KING'S CROSSING VILLAGE

SITE PLAN WITH ADJUSTMENTS

KING'S CROSSING VILLAGE
SITE PLAN WITH ADJUSTMENTS
15660 E 6TH AVE, AURORA, CO 80011
COVER SHEET

KING'S CROSSING VILLAGE
SITE PLAN WITH ADJUSTMENTS
SITE PLAN

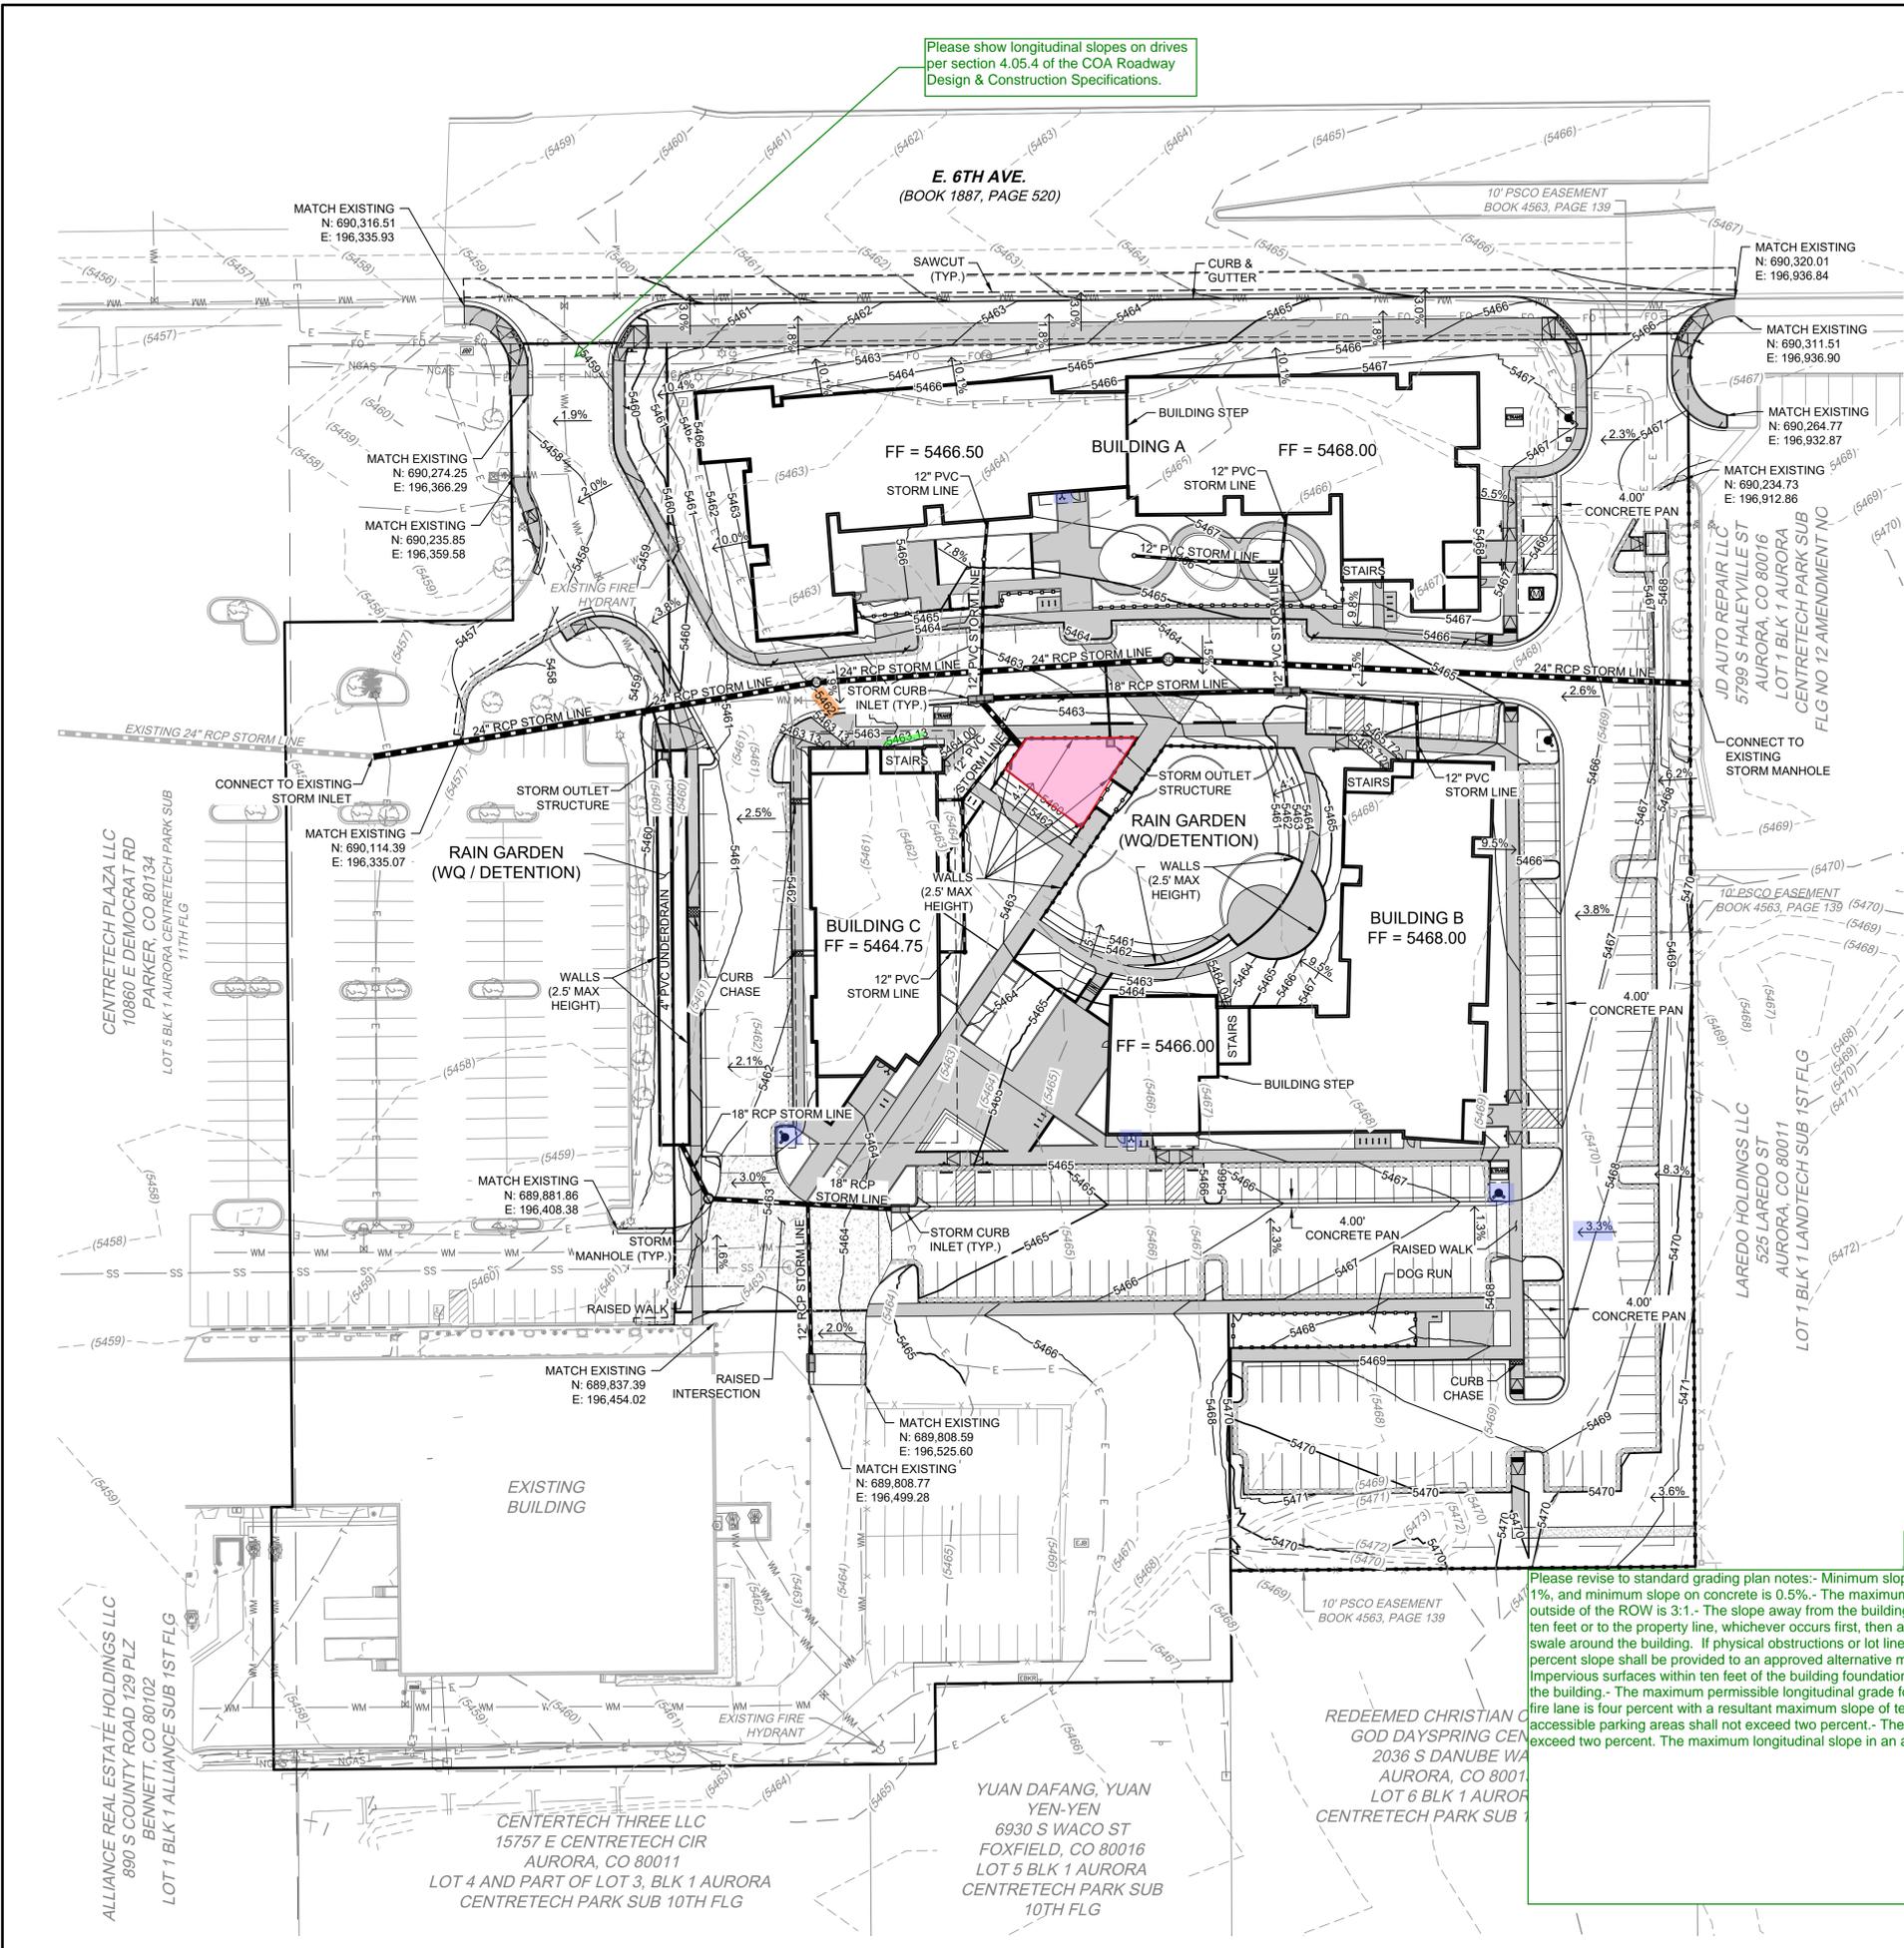
Show the location of all existing and proposed water mains and fire hydrants within or abutting this site. The location and bearing of existing fire hydrants located (within 400' or the next existing fire hydrant) outside the plan area shall utilize a fire hydrant symbol with an arrow identifying the distance from the symbol to the existing fire hydrant.

The fire lane radii should meet the requirements in Section 4.07.1.01 in the Roadway Manual. Please show/label the proposed outside radii for the fire lanes (52-foot min.)

Provide a safe crossing mechanism from the development to adjacent development. See Table 4.5.4 in the UDO.

- The FDC, FDC sign, and Knox Box location must be shown on the site plan and civil plan sign package using a label and symbol.
- An FDC sign is required above the FDC.
- The FDC must be within 100' of a Fire Hydrant. The 100' measurement is within the vehicular drive aisle and not the most direct path between two points.
- Label Fire Department Connections using the following examples: FIRE DEPARTMENT CONNECTION WITH APPROVED KNOX CAPS OR FDC w/app'd Knox Caps
- Include the FDC, FDC sign, and Knox box label and symbols in the Legend.

Fire Lane placement should include being located 20 feet from any intersection. Please add this detail to the Fire Lane Sign Notes.

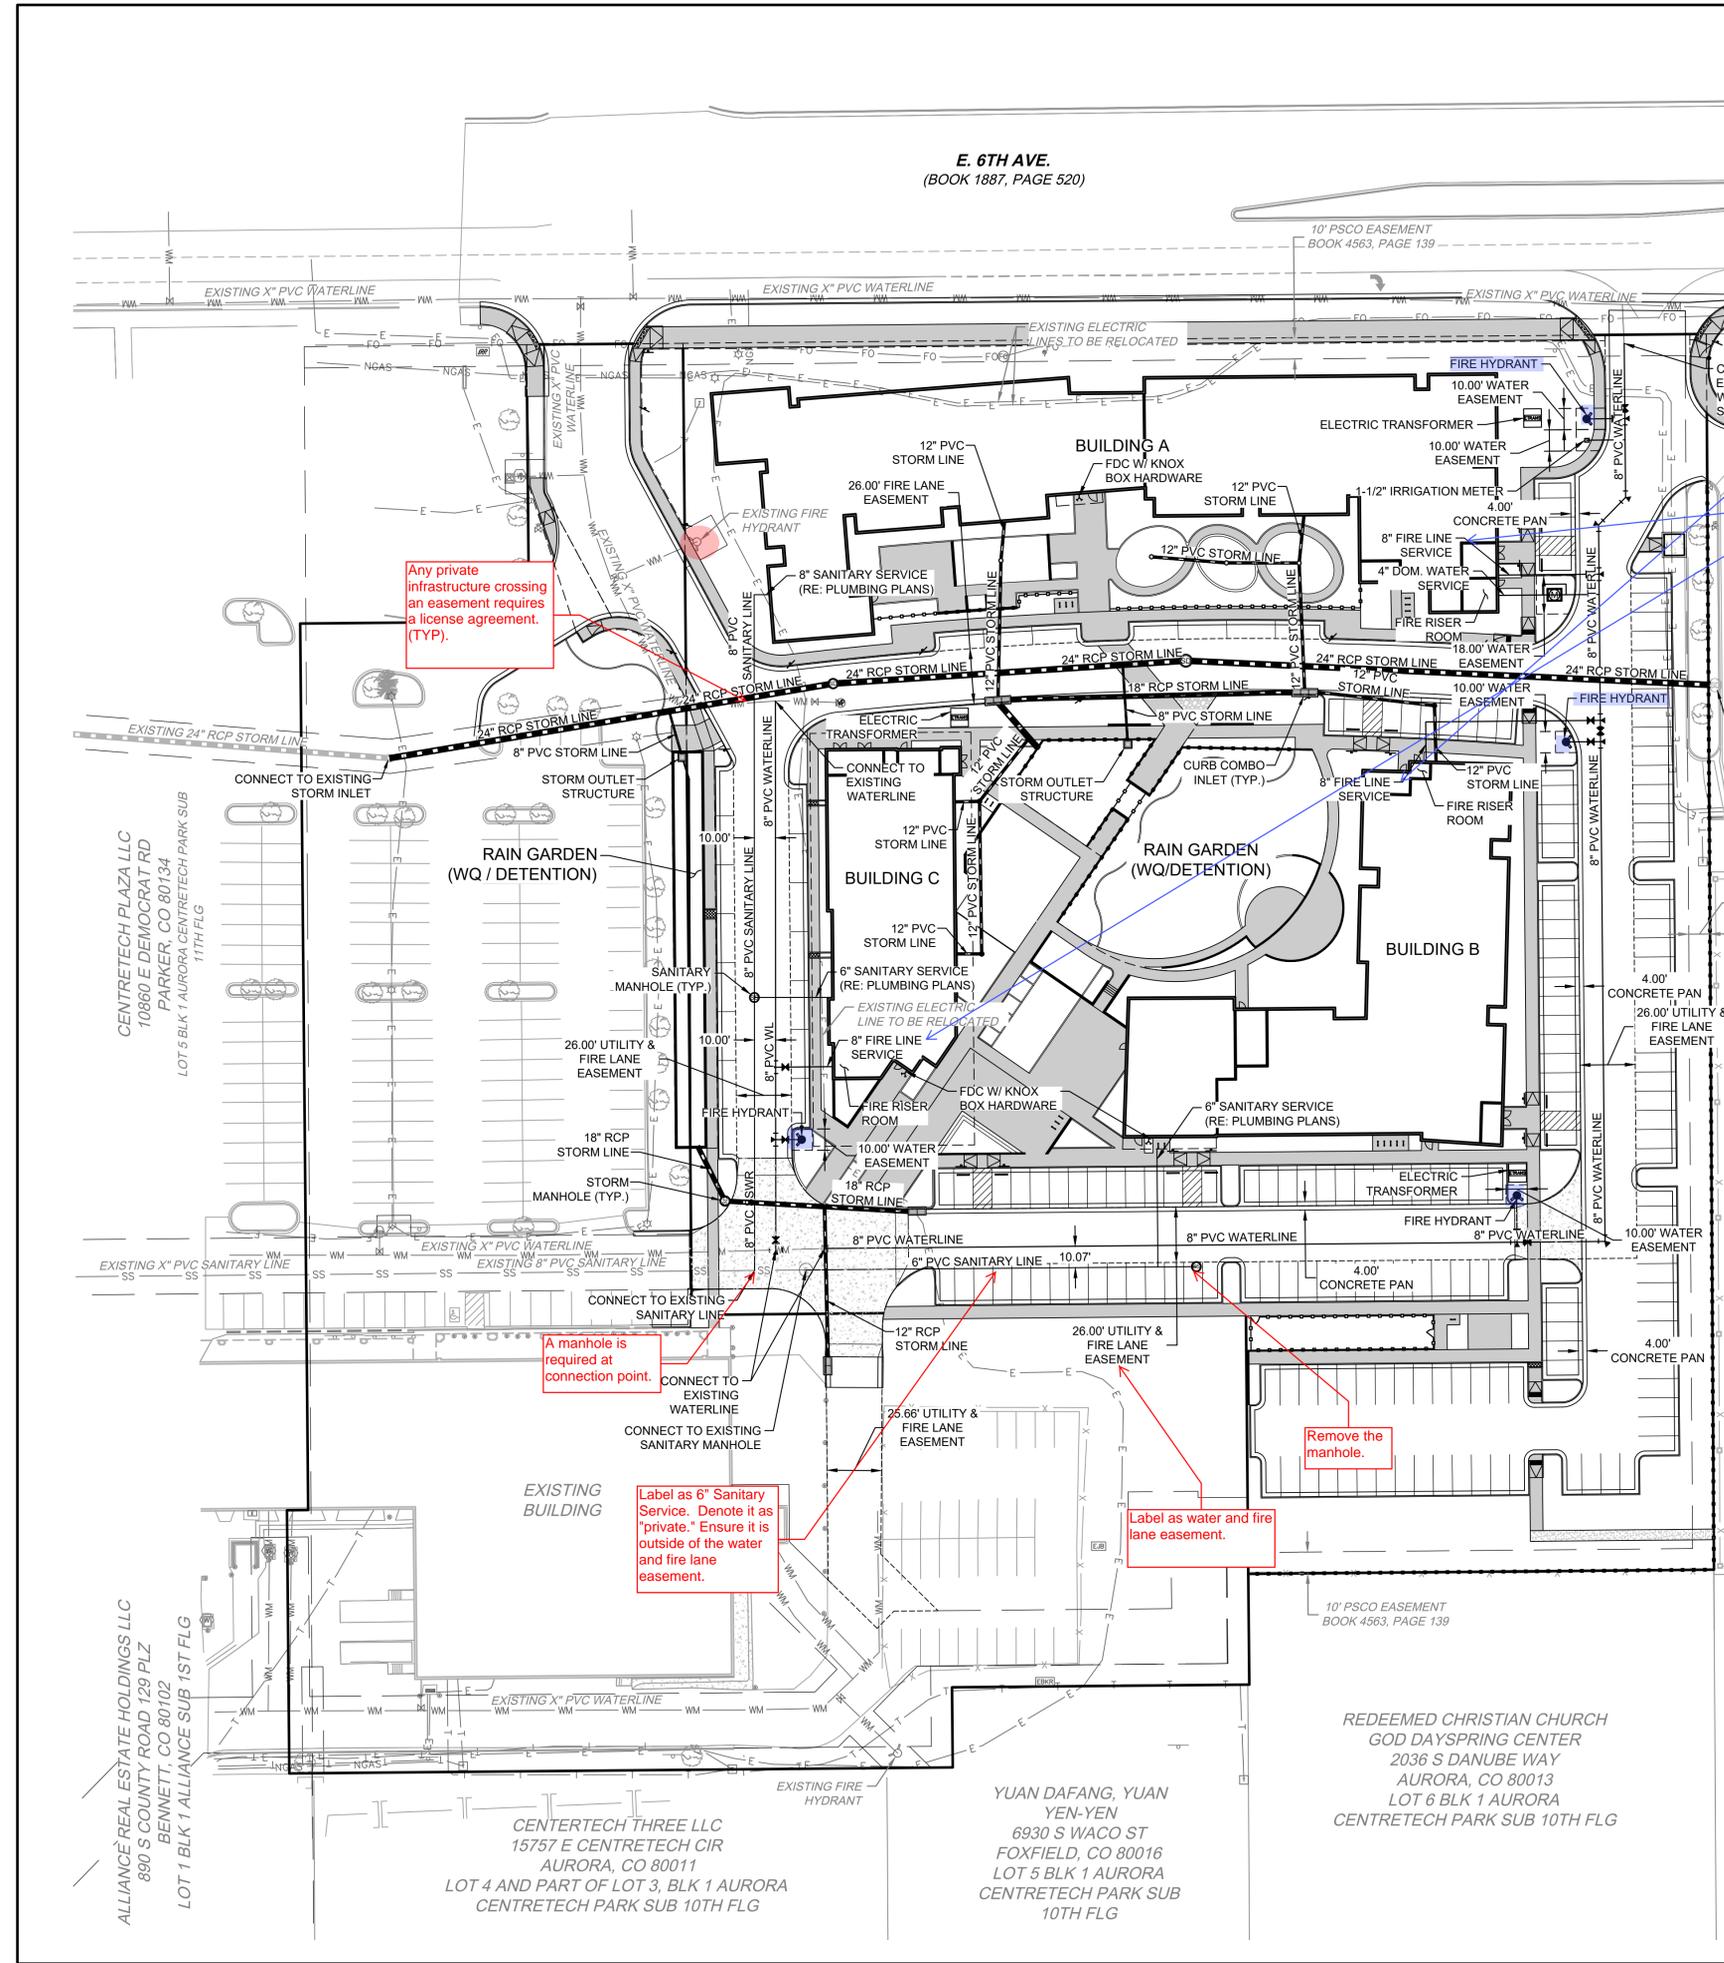
Show and label Fire Service Line using the following example: 4" Fire Service Line (Private).

Any private infrastructure crossing an easement requires a license agreement. (TYP.)

Verify the stub exists for connection point. Otherwise, a connection at the main will be required.

Remove the manhole.

A LANDSCAPE SITE PLAN
SCALE: 1" = 30'

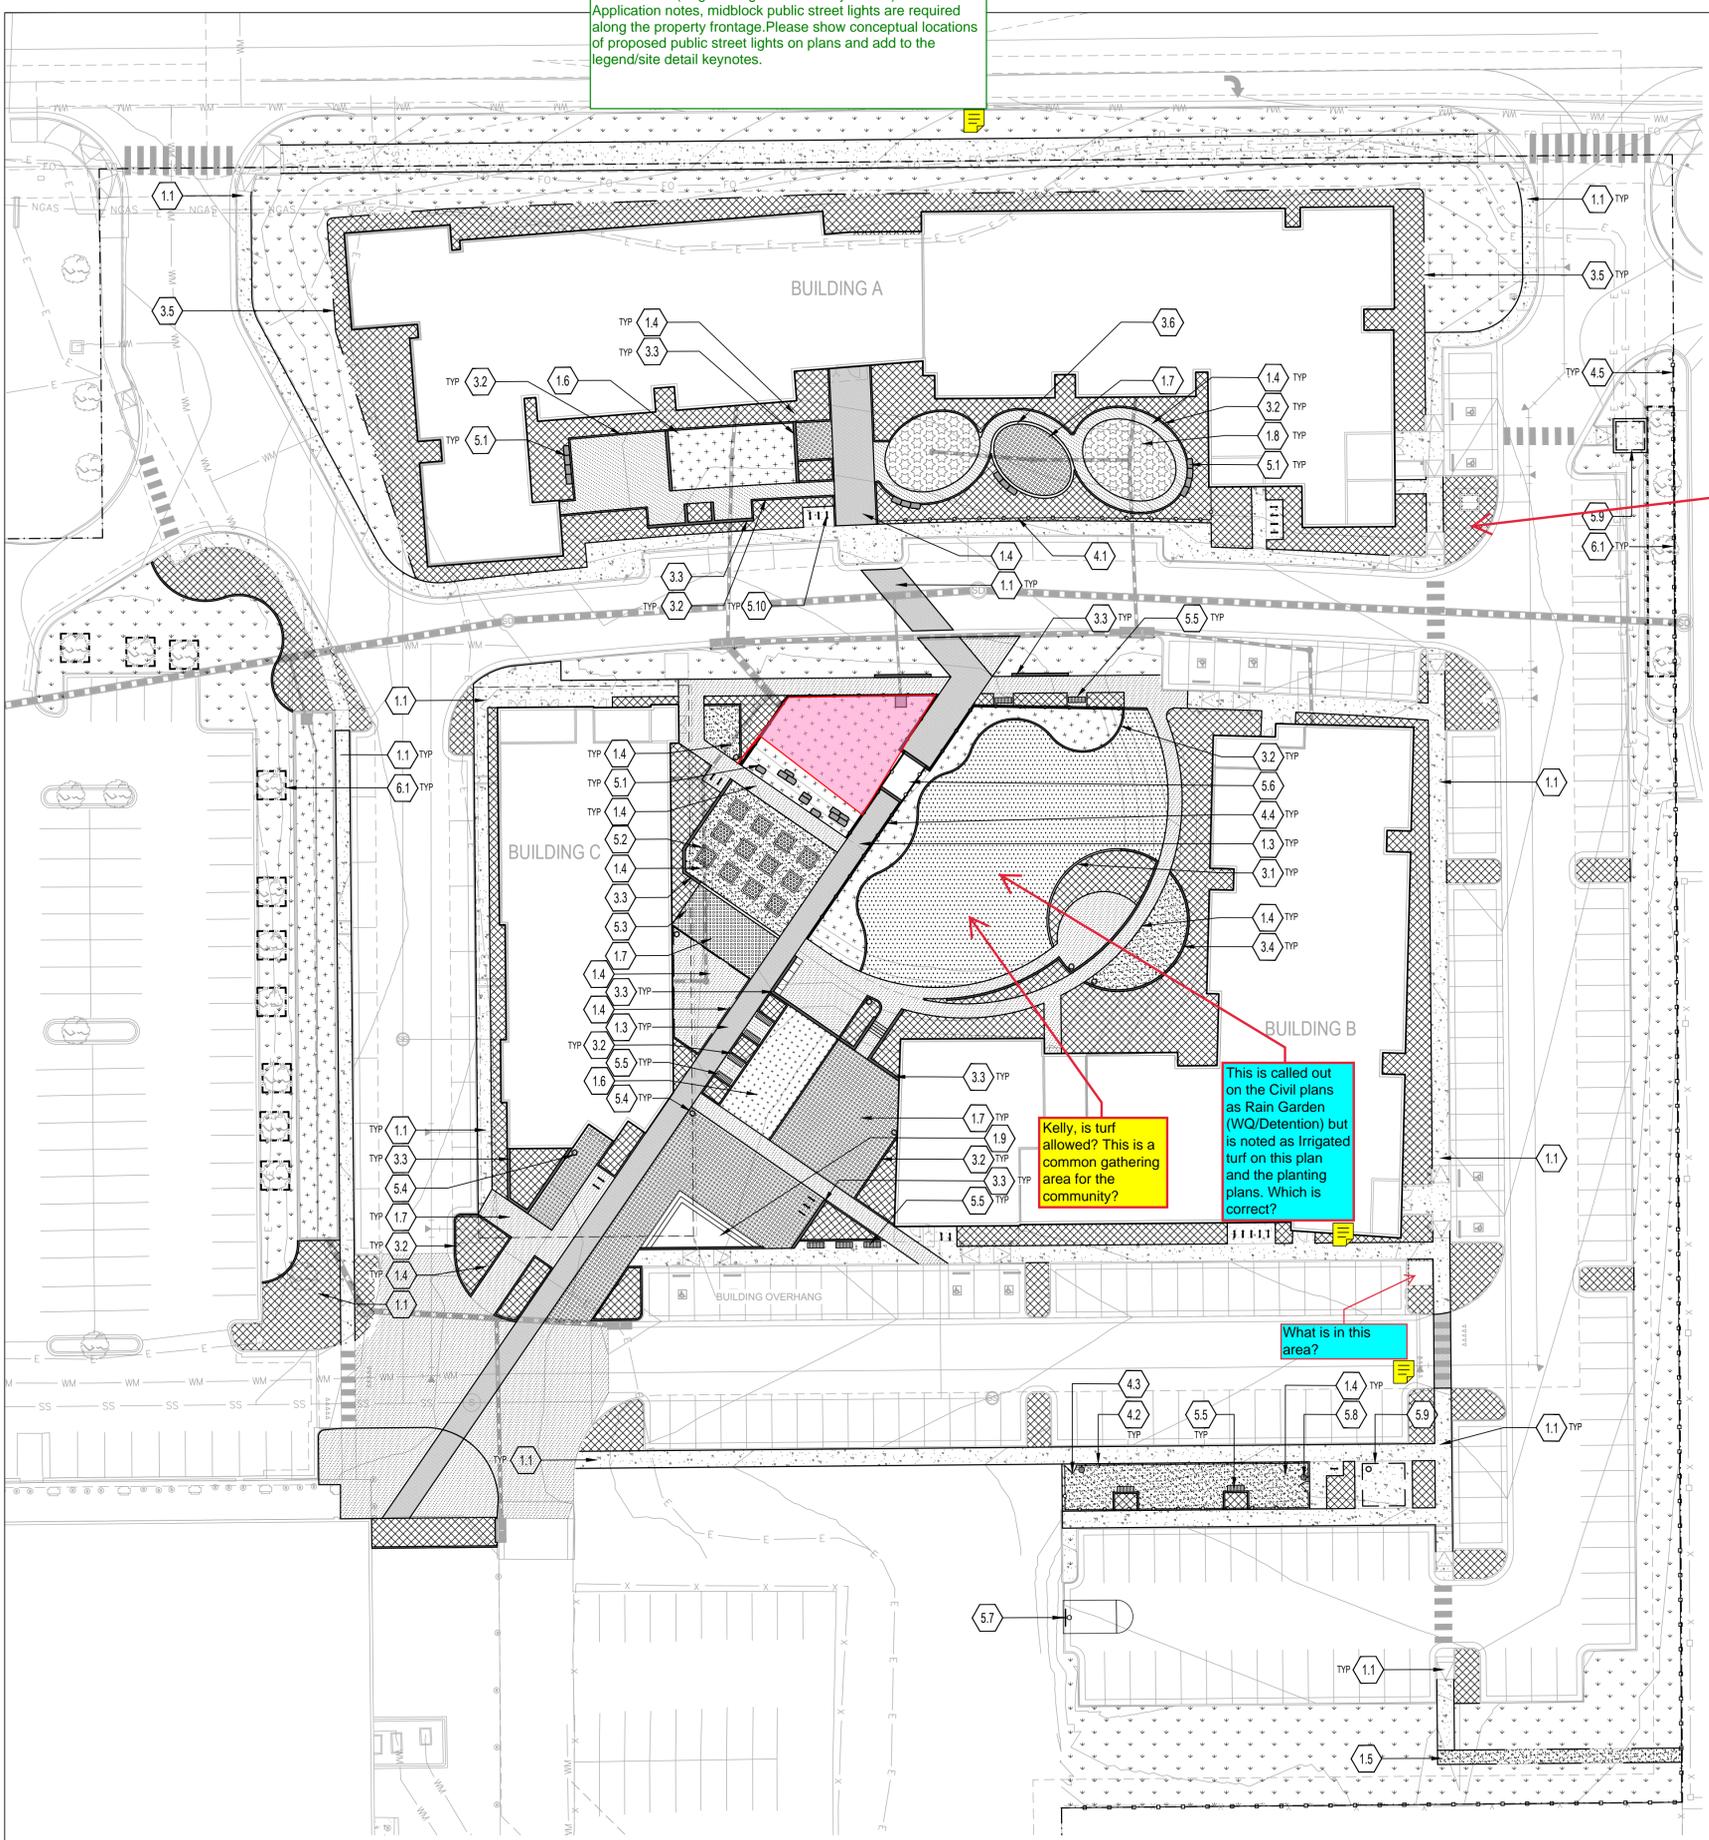
Per sheet 20 (Engineering Division - Key Issues) of the Pre-Application notes, midblock public street lights are required along the property frontage. Please show conceptual locations of proposed public street lights on plans and add to the legend/site detail keynotes.

The Landscape Plan must reflect the locations of all Fire Hydrants, Knox Hardware, and Fire Department connections to ensure that devices are not physically or visually obstructed from responding Fire Crews. Please include a Legend with symbols.

This is called out on the Civil plans as Rain Garden (WQ/Detention) but is noted as Irrigated turf on this plan and the planting plans. Which is correct?

The Planting Plan should follow sheet 6 with the Planting Tables.

Provide total sheet set numbering that should be cumulative for the entire set. Include Sheet X of X.

A CEDAR FENCE
SCALE: 1/2" = 1'-0"

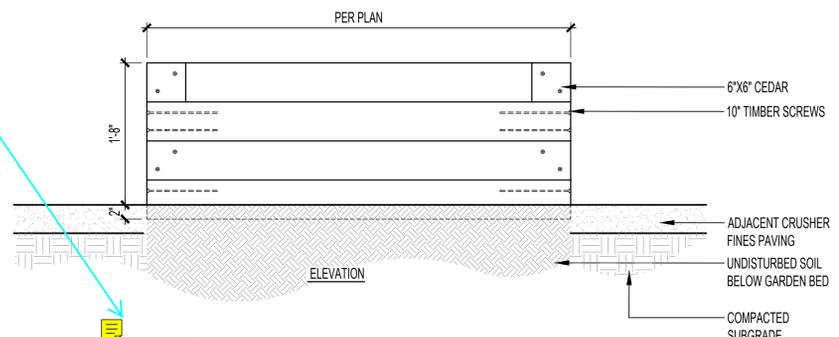
Show location on site plan.
